FINAL PRODUCT/PROCESS CHANGE NOTIFICATION # 20411

Issue Date: 17-Apr-2014**TITLE:** Qualification of ON Semiconductor Pocatello (wafer fab) in SOT143 device CM1223-02SR.**PROPOSED FIRST SHIP DATE:** 17-Jul-2014**AFFECTED CHANGE CATEGORY(S):** Die layout & wafer fab site**FOR ANY QUESTIONS CONCERNING THIS NOTIFICATION:**

Die layout change:

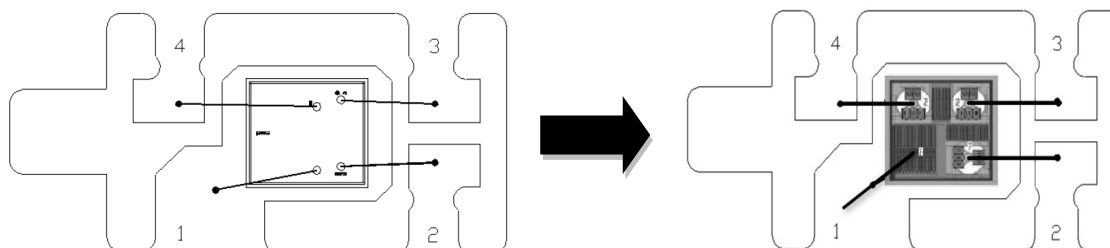
This is the final notification announcing that for CM1223-02SR, the wafer fab will be transferred to On Semiconductor Pocatello in Idaho, USA. This fab site is ON Semiconductor's internal factories and certified for ISO/TS 16949. This product will continue to meet RoHS requirement and also Halide Free.
